PREPARED	NAME L. Pazmany	5-10-80	PAZMANY AIRCRAFT CORPORATION — SAN DIEGO — CALIFORNIA —	MODEL NO.	PL-2
CHECKED			ENGINEERING CHANGE NOTICE # 5	REPORT NO.	
APPROVED				PAGE NO.

DWG 2-10-011 - SHT1 - VIEW D-D

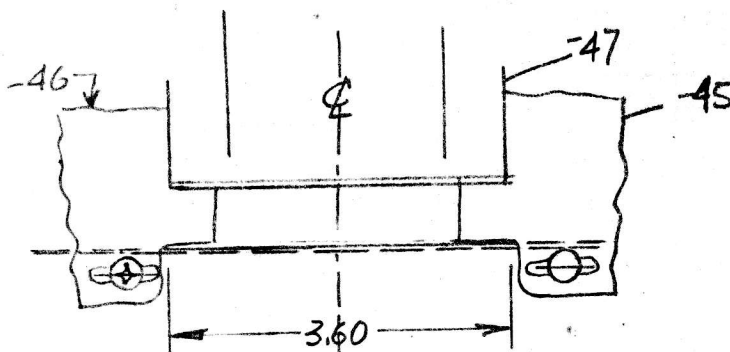
MODIFY -45 & -46 TO
 CLEAR THE FUEL PUMP
 BOX AS SHOWN. MOVE
 TWO NUTPLATES OUTBOARD
